Arcadis Project No.:
MI001322.0001

Subject:
DEQ Information Request Regarding Ford LTP
On site VI Investigation Plan

Response to MDEQ Request for Information

Ford Livonia Transmission Plant

Borings Completed to Date

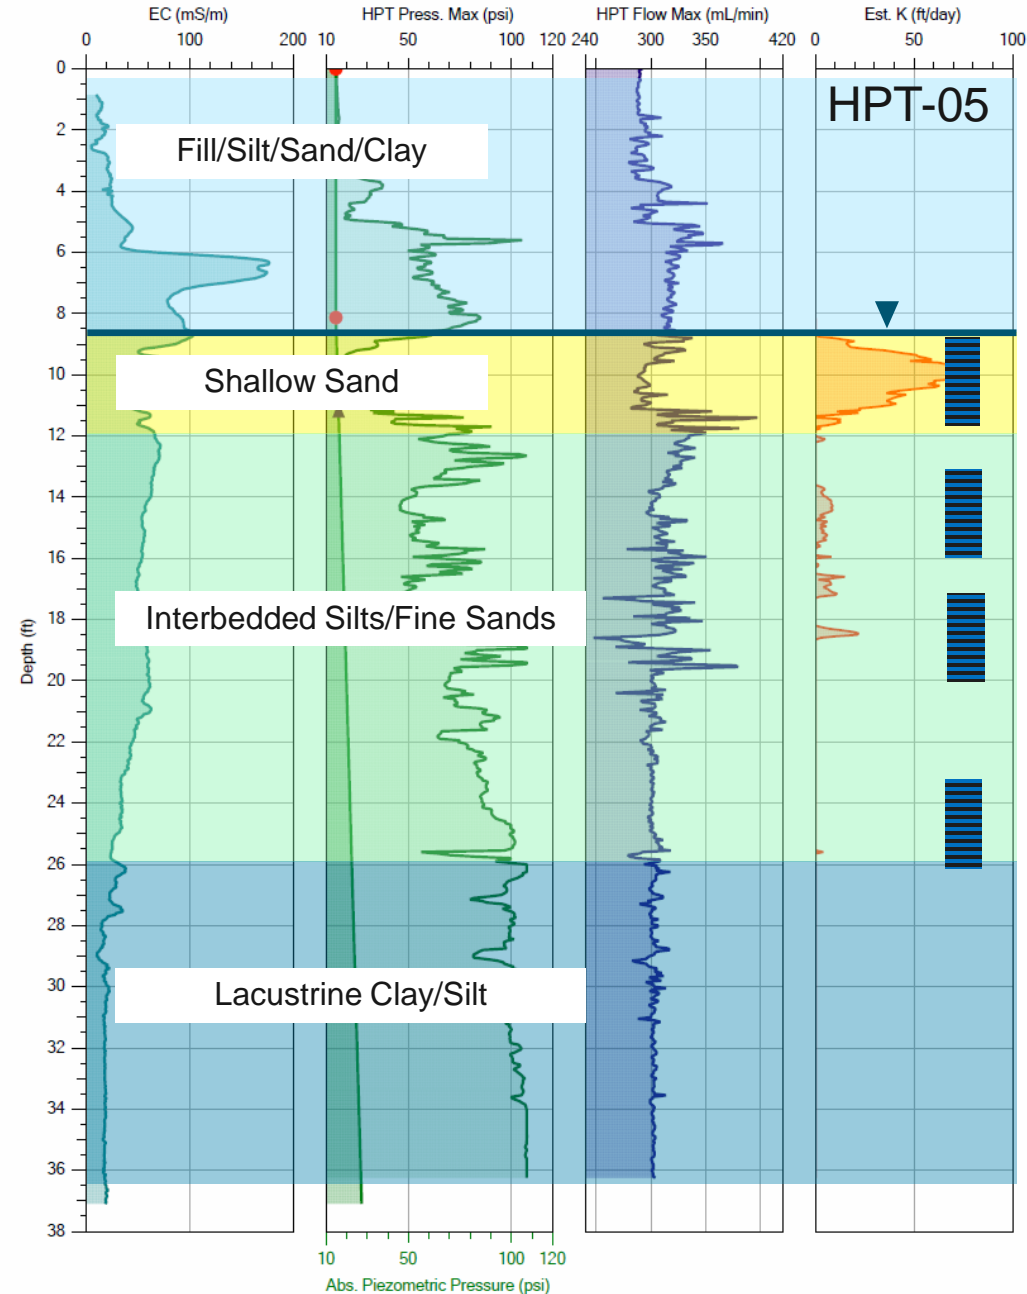
The current CSM incorporates existing site knowledge (such as geologic setting) with high-resolution permeability profiling and sampling. Borings completed as part of the Remedial Investigation (RI) are included on Slide 4. Exterior work has focused on permeability mapping with the Geoprobe™ Hydraulic Profiling Tool (HPT; Slide 5) and high-frequency vertical aquifer profile (VAP) groundwater sampling to characterize the hydrostratigraphy, contaminant distribution, and mass flux. Beneath the LTP building, high-frequency soil sampling was completed in lieu of VAP sampling to evaluate volatile organic compound (VOC) distribution through the LNAPL and within the saturated soil column. LNAPL delineation used a state-of-the-art laser-induced fluorescence (LIF) hydraulic profiling (LIF-HP) tool to simultaneously map LNAPL distribution and log the relative permeability of the soil. Based on LIF/LIF-HP results, LNAPL monitoring wells were installed for LNAPL sampling and mobility testing.

Stratigraphic Flux Model

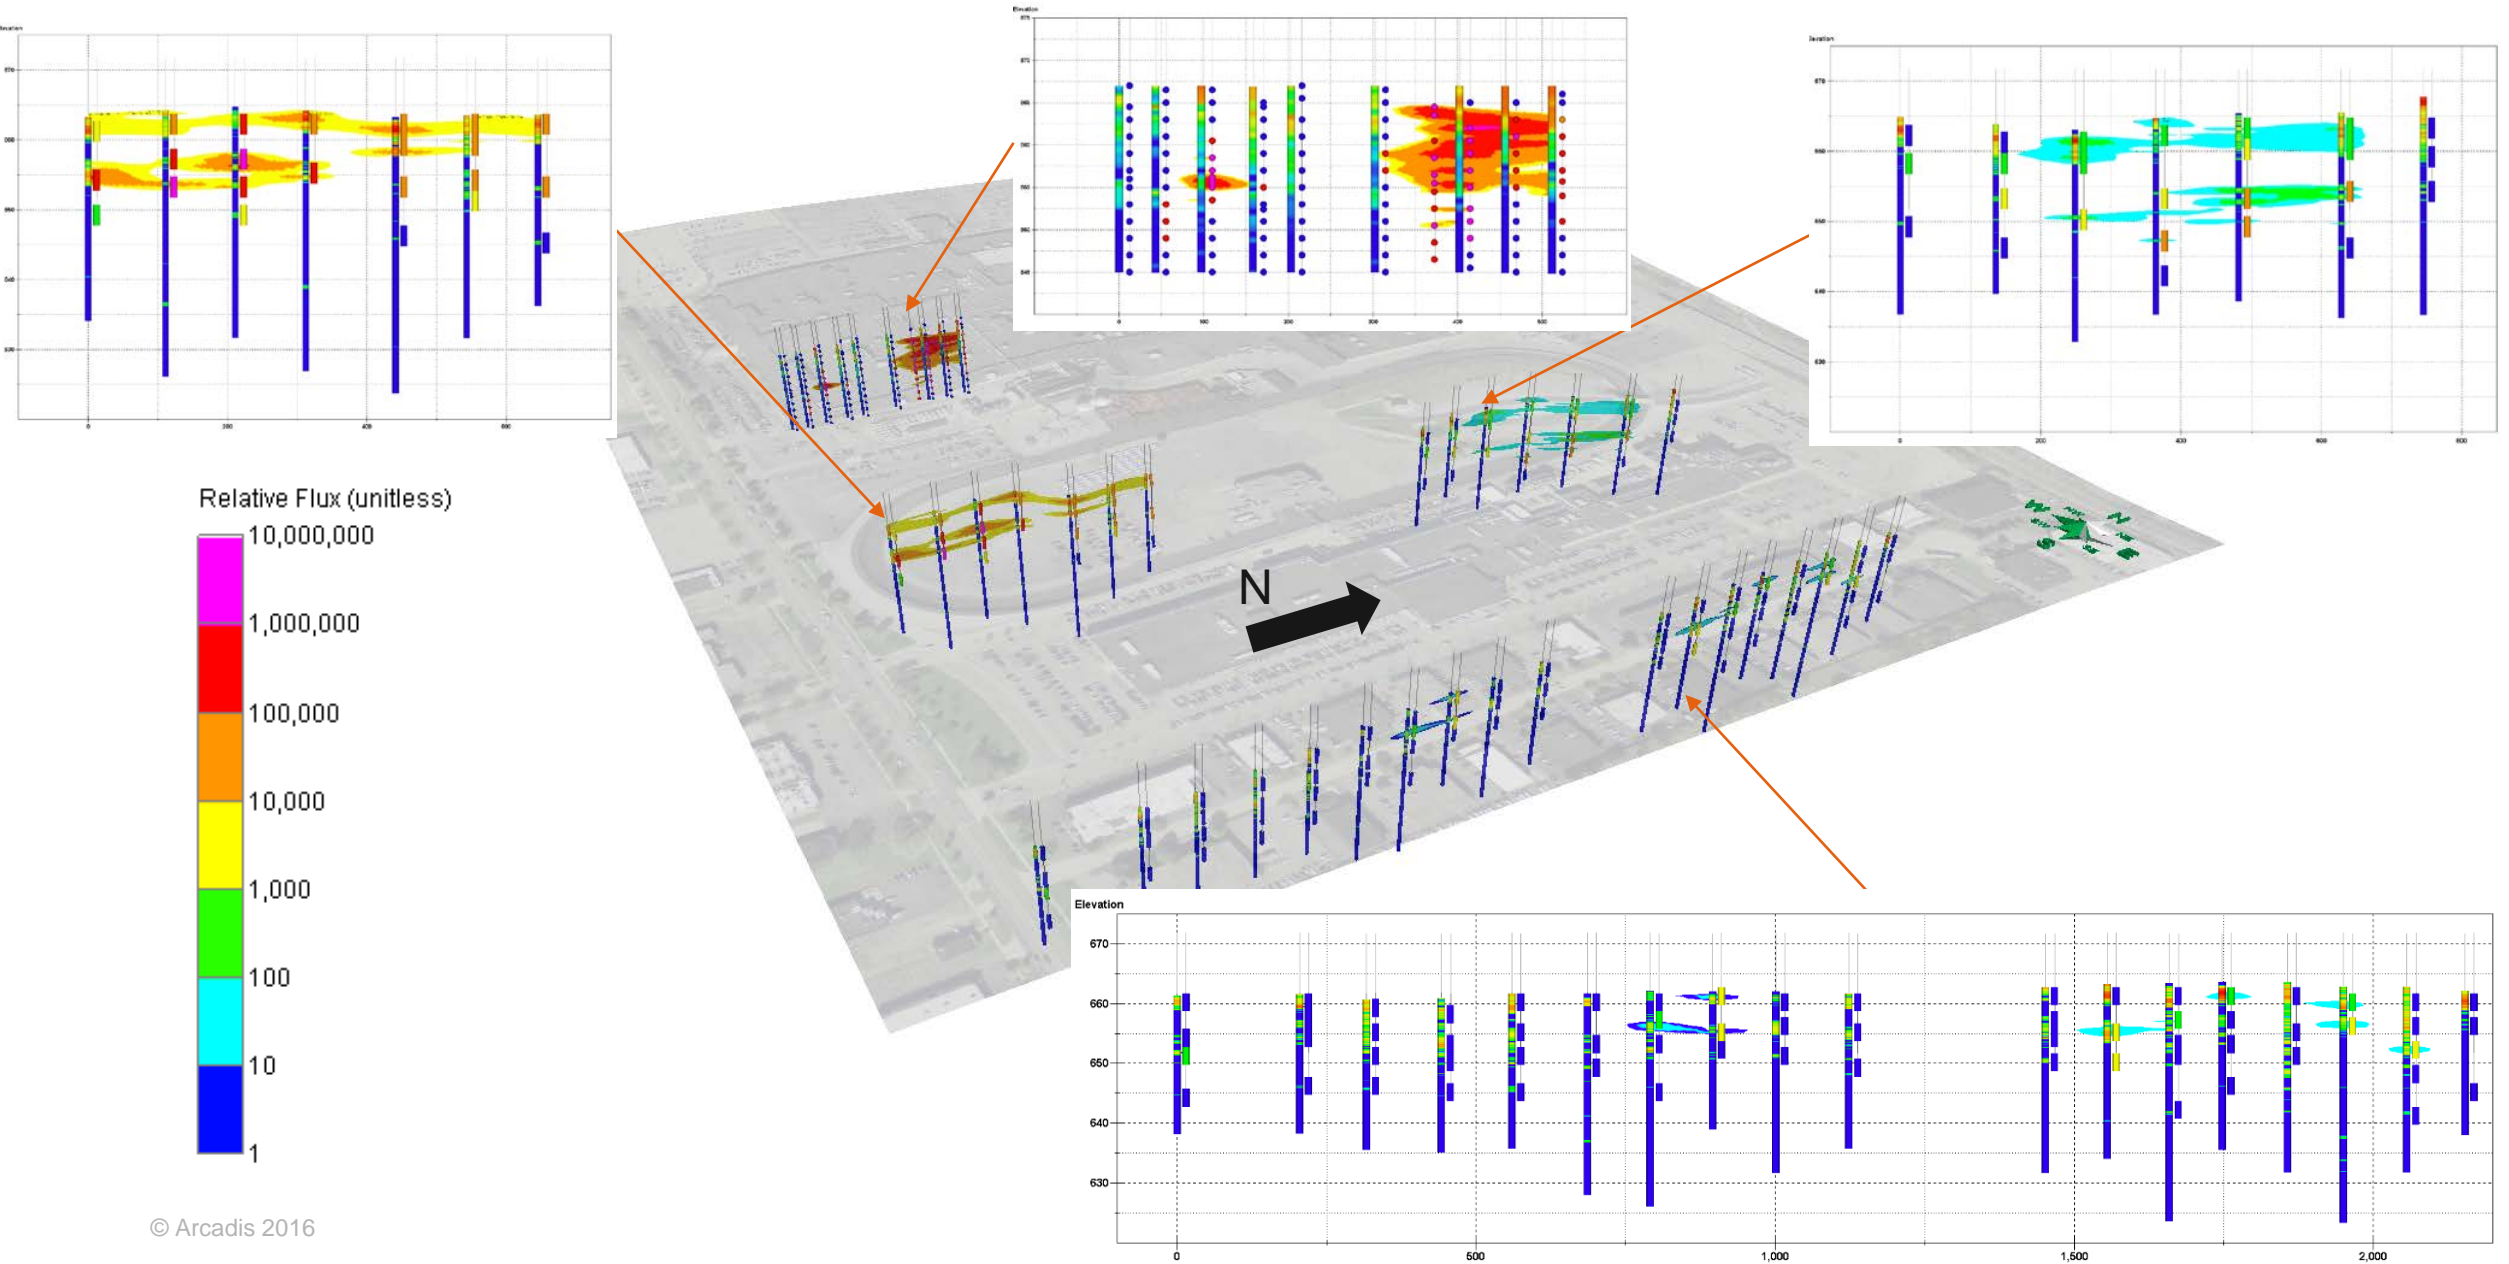
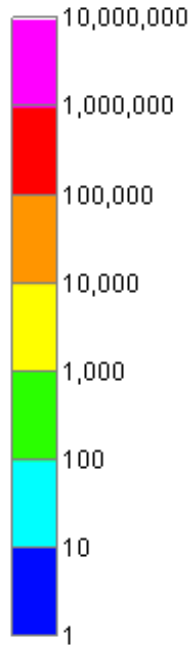
Slide 19 provides a stratigraphic flux model that illustrates a relative measure of mass flux along each HPT transect. The stratigraphic flux is derived by multiplying the 3-D permeability field determined with HPT or LIF-HP, with the concentration field determined using VAP or saturated soil sampling. The result illustrates a five order-of-magnitude decrease in relative mass flux between the source area(s) located beneath LTP and the eastern property boundary. This result suggests that groundwater impacts attenuate rapidly between the source area and the eastern property boundary, likely due in part to anaerobic dechlorination of chlorinated VOCs (CVOCs) due to conditions created by the presence of LNAPL beneath the LTP building. In addition, migration of groundwater impacts on the southeastern portion of the Site were historically hindered by the presence of the eastern storm drain (Slide 20) as described further below.

Discharge to Eastern Storm Main

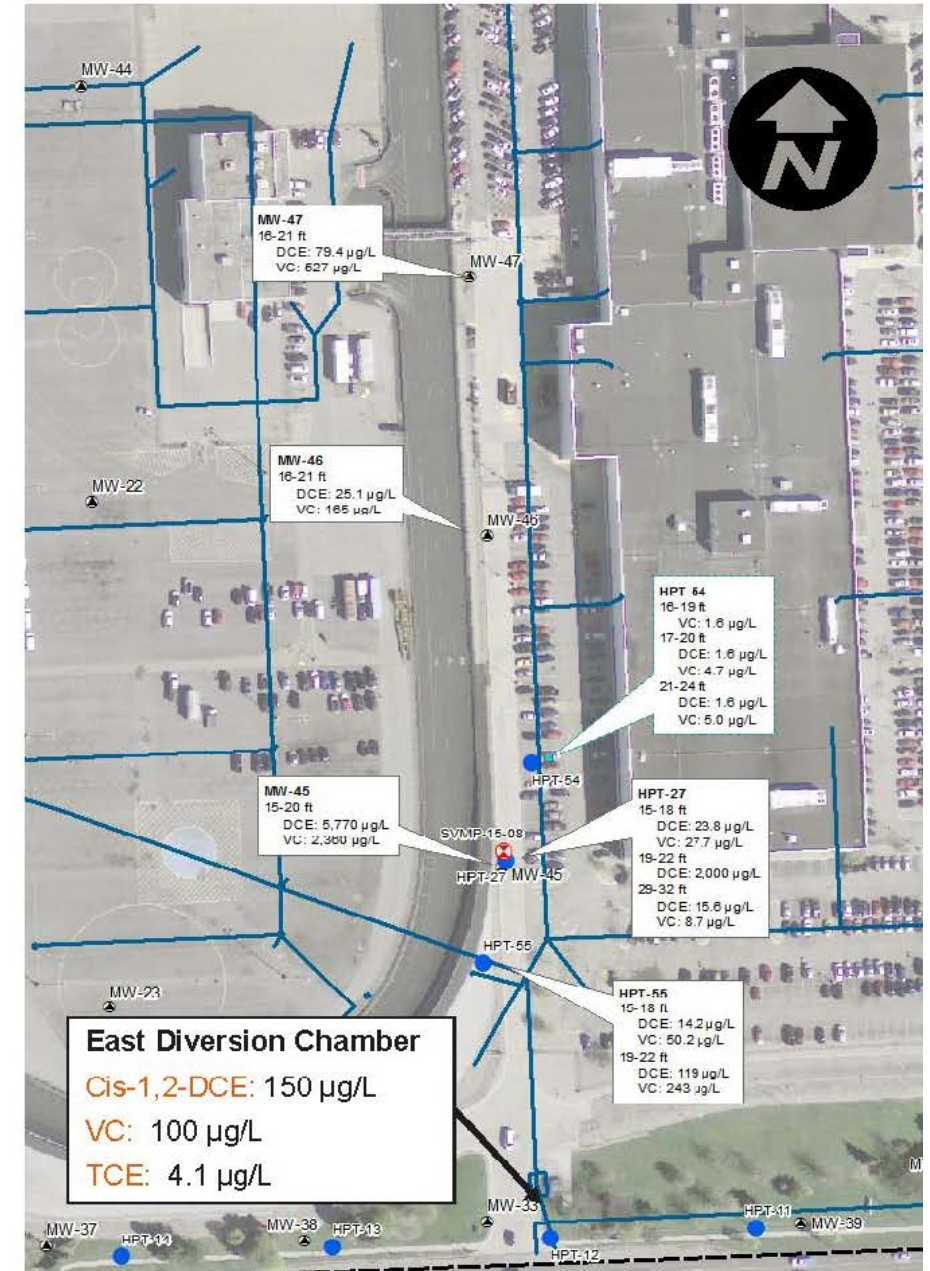
Comment #5: *Is the storm drainage condition which is believed to have helped slow down the migration of this contamination to the south still present? Is this still being addressed for a more appropriate long-term solution in which the contaminated groundwater is not being intercepted by the storm sewer, or is a long-term solution now in place?*

Based on the distribution of VOCs and groundwater low identified near MW-45 on the southern portion of the Site, the eastern storm main was identified as receiving the bulk of VOCs migrating east of the LTP building

- Groundwater plume at 8 ppm total VOCs west of storm main, diminishes to the east
- Storm water discharges to sanitary sewer, under base flow conditions
- Permit 006-27510-IU issued by Great Lakes Water Authority on March 23, 2017
- Groundwater low around MW-45 area

LNAPL Delineation

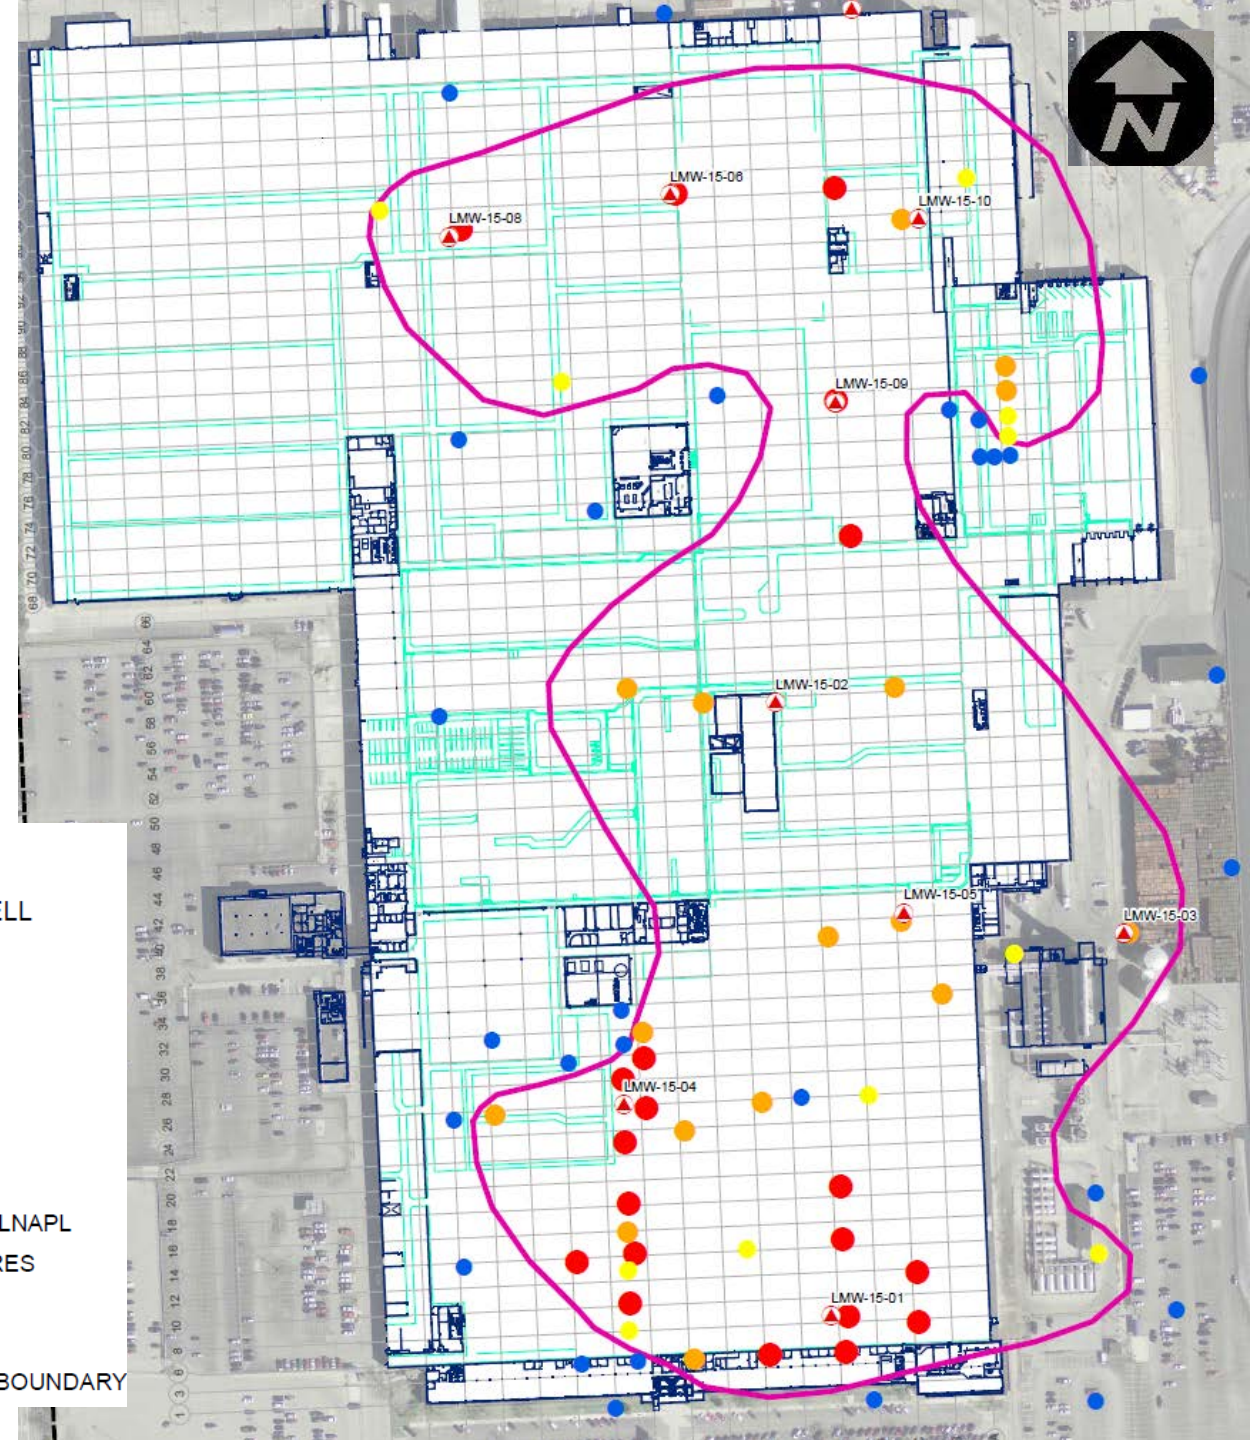
The lateral extent of LNAPL, based on the LIF and LIF-HP data, is illustrated on Slide 22. In general, the LNAPL consists of a mix of transmission, cutting, and hydraulic oils (Slide 24). Low concentrations of PCBs were detected in LNAPL, but at generally low concentrations (i.e., <5 parts per million). The specific PCB congeners detected suggest that all of the PCBs were released before 1971 (slide 25). There are some areas of elevated VOCs within the LNAPL; most notably at well LMW-15-05, where 1,1,1-TCA and cis-1,2-DCE were detected at concentrations greater than 100 parts per million (Slide 26).

Industrial Hygiene Air Sample Data

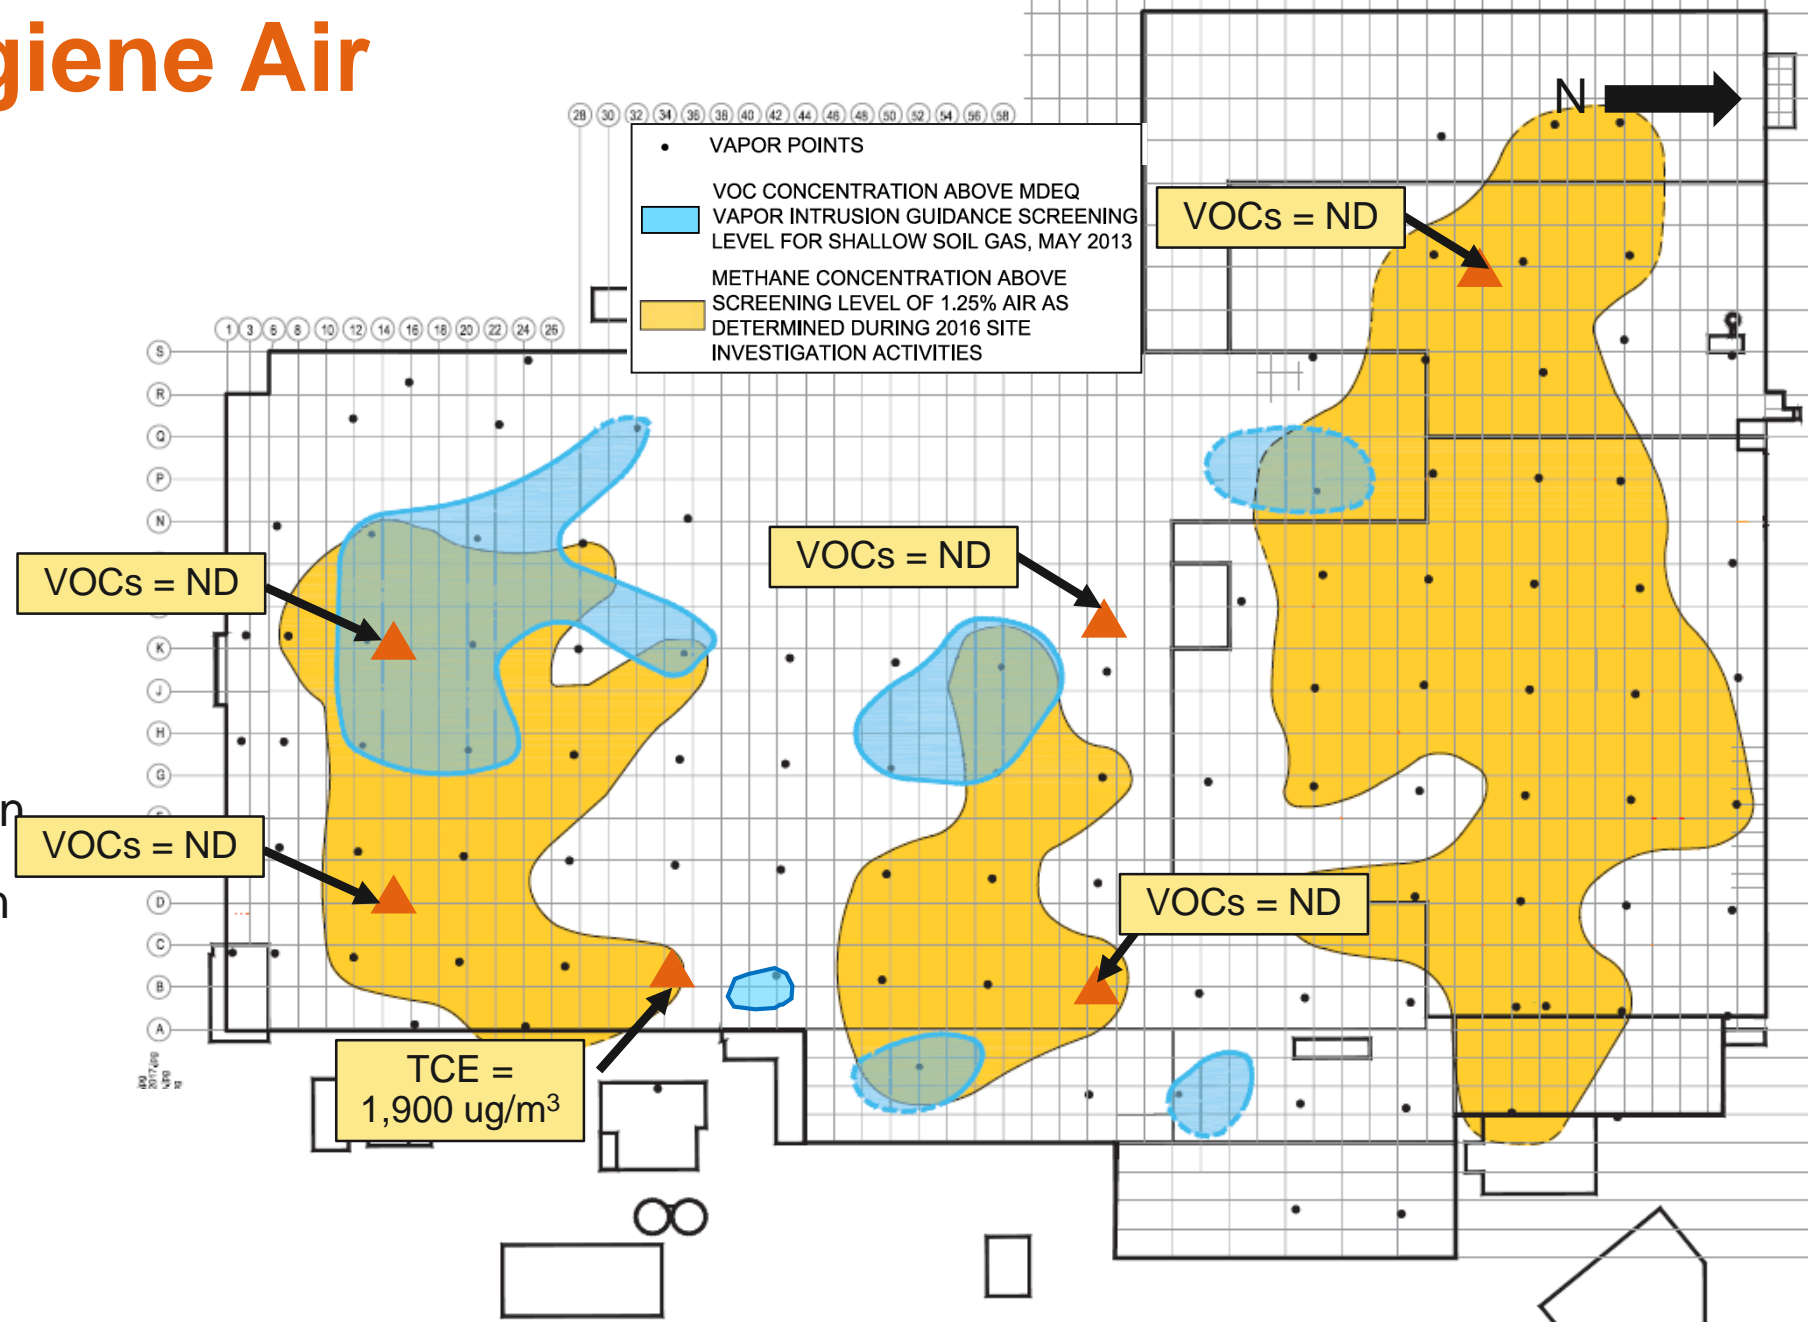
- Indoor air sampling at six locations inside the plant in July 2015 (Golder) using industrial hygiene sampling methods (Slide 35). The detection limits of these samples (0.1 parts per million by volume [ppmv] for VOCs) limit the utility of the data for assessing the potential for vapor intrusion. VOCs were not detected in five of the six indoor air samples. At the sixth sample location, TCE was detected; however, a trench to the sub-grade was open during construction, skewing the sampling results high and not representing normal operating conditions.
